# LAX Community Noise Roundtable

**SUBJECT: Working Together to Try to Make NextGen Livable**

**Comments on Proposed Revisions to the Three STAR IFPs that Compose the LAX North Arrival Downwind Leg**  
**STAR HUULL (RNAV) TWO LOS ANGELES CA KLAX**  
**STAR IRNMN (RNAV) TWO LOS ANGELES CA KLAX**  
**STAR RYDRR (RNAV) TWO LOS ANGELES CA KLAX**

# Presentation on Five Proposed New/Revised FAA North Arrival Flight Procedures for LAX.

## HUULL 2 – Blow up of LA Basin end of approach

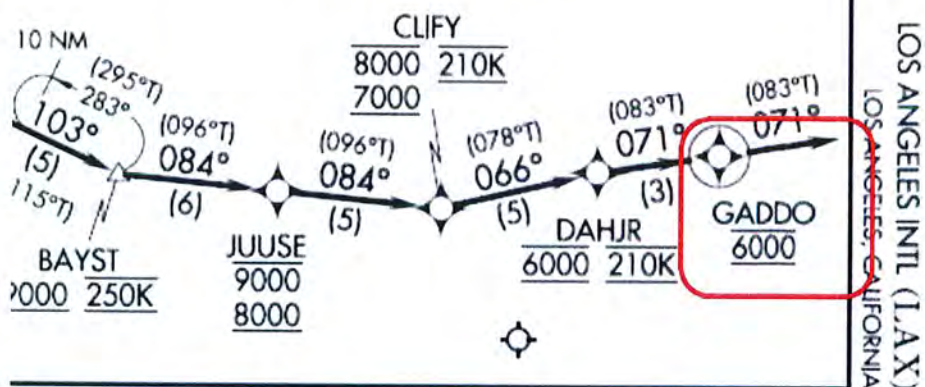
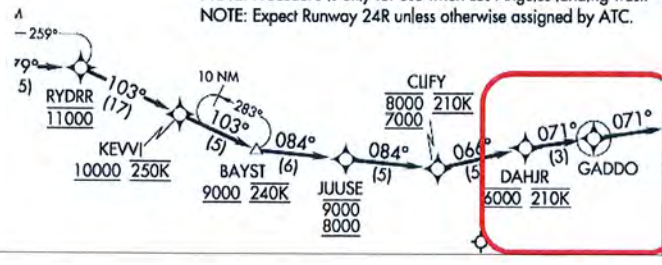
1. The LAX RT unanimously endorses the assignment of a Mandatory Minimum Altitude (Min Alt) of 6,000 feet at Waypoint GADDO in all three IFPs. This is a positive step toward alleviating intolerable noise imposed on many thousands of residents under these North Arrival flight paths. We urge prompt publication and implementation of these revised IFPs.
2. However, we still have several critical concerns about the design and implementation of these IFPs:

- a. FAA Air Traffic Control (ATC) must ensure the newly assigned Mandatory Min Alt of 6,000 feet at GADDO is consistently realized by aircraft.
- b. Since the April 27, 2017 implementation of the first versions of these IFPs, an inexcusable 67% of aircraft crossing Waypoint DAHJR, which immediately precedes GADDO, have failed to meet DAHJR's Mandatory Min Alt of 6,000 feet. This must be rectified.

- c. The FAA Flight Standards Service reports for the subject IFP revisions state that the "Reason" for the FAA's "Change" to assign a Mandatory Min Alt at GADDO is that a Min Alt is "REQUIRED PER FAAO 8260.3C PARA 2-2-1f(6)(b)." This rule has been effective since at least March 14, 2016 - more than one year before the April 27, 2017 publication of version 1 of these three IFPs. The rule requires that a terminal fix must have a Min Alt. While we absolutely support the assignment of a Mandatory Min Alt at GADDO, we are disturbed that this limit was absent since inception on April 27, 2017. Many thousands of residents have suffered from this error.

## SADDE 8 - Blow up of LA Basin end of approach

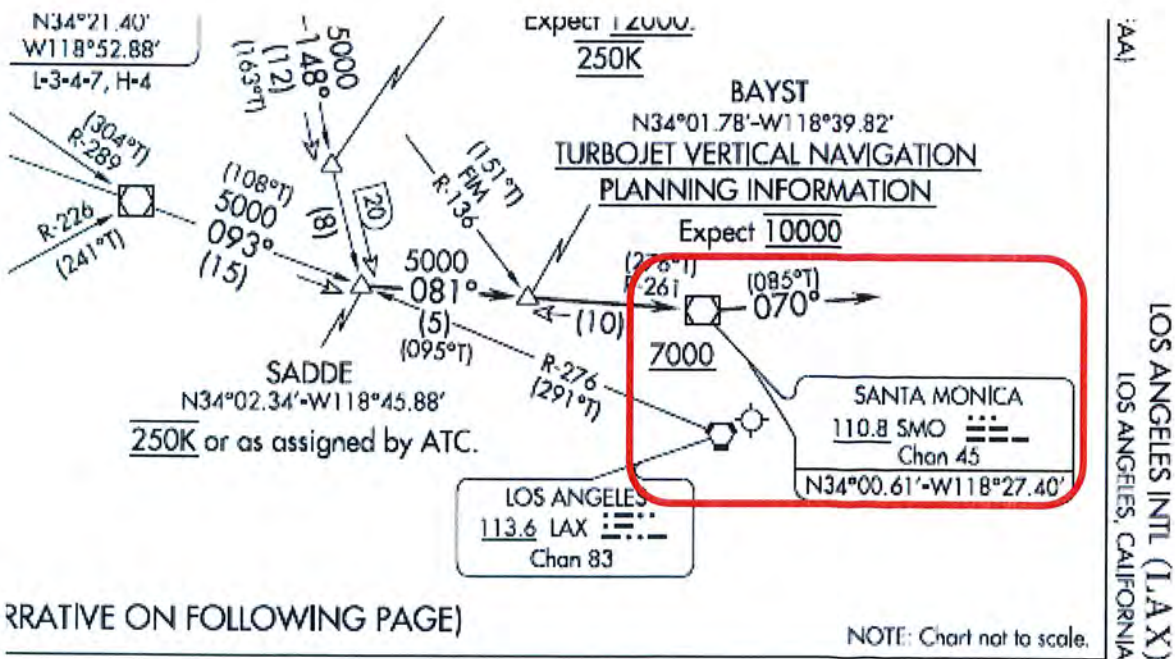
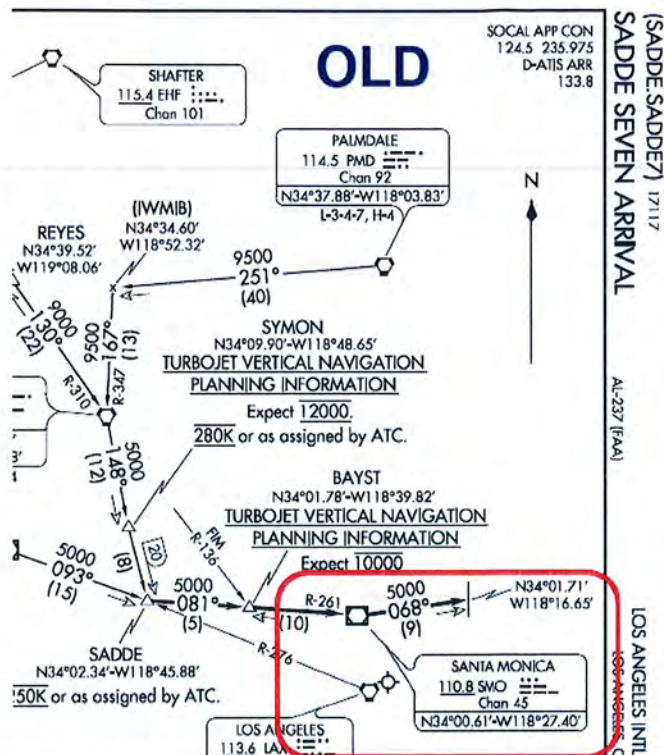
- c. Achieving Min Alt levels in SADDE 8 and other procedures, whether RNAV or conventional, is a priority issue that the FAA ATC must rectify.
2. We also have additional critical concerns about the design and implementation of this IFP, all of which we wanted the FAA to address at our September 13, 2017 regularly scheduled meeting of the LAX RT, but the FAA refused to brief us on these IFP's even though they were open for public comment. Our comments are based solely on basic information on the website. More info is necessary to produce totally informed comment.

- a. Why is this conventional STAR being revised and continued, and not being replaced by RNAV IFPs?
    - b. How many aircraft are expected to be assigned to follow the SADDE 8 procedure? Approximate numbers, a percentage of North Arrival flights, and a sense of frequency would be helpful for us to know

- e. What are the likely vector paths after SMO? What are the possible vector paths after SMO? What are the likely altitudes after SMO?
    - f. The FAA Flight Standards Service report for the subject IFP revision states that the "Reason" for the FAA's "Change" to assign a Min Alt at Santa Monica SMO is that "An altitude restriction is required by criteria at the STAR terminus." Like similar changes being made on HUULL 2, IRNMN 2, and RYDRR 2, it seems to us that this change is necessary to bring SADDE 7, the exiting IFP, into compliance with FAAO 8260.3C PARA 2-2-1f(6)(b).

## BAYST 1 – Blow up of LA Basin end of approach

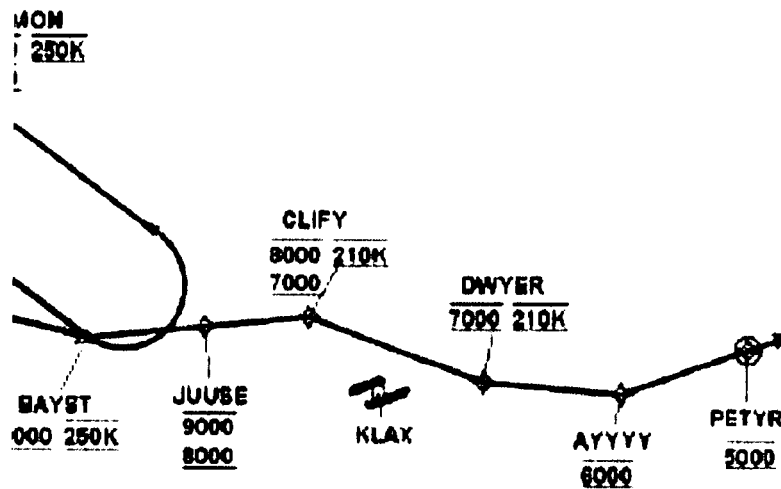
- ii. LAWA staff said they believe the flight path proposed in BAYST 1 is a formalization (with changes) of a similar but unpublished route to land on the South Runway that has been flown conventionally (not RNAV) from time to time over the years. Is that correct? Why is

iii. LAWA staff said they believe the BAYST 1 procedure is likely to be used only under special circumstances, such as bad weather or traffic overloads, but could not confirm that. The documents on the Information Gateway do indicate that the procedure is “to be assigned by ATC,” but add nothing more. Under what circumstances will this procedure be used? And how often?

b. We also have a couple of concerns about Minimum Altitudes on the procedure. We regard these as important questions because this is a new IFP with a new flight path that was not, to the best of our knowledge, considered in the Metroplex Environmental Assessment. The Min Alt questions take on more importance if BAYST 1 is principally for cargo aircraft that are noisier than passenger aircraft, plus cargo flight are often arriving at the highly sensitive late night and early morning hours:
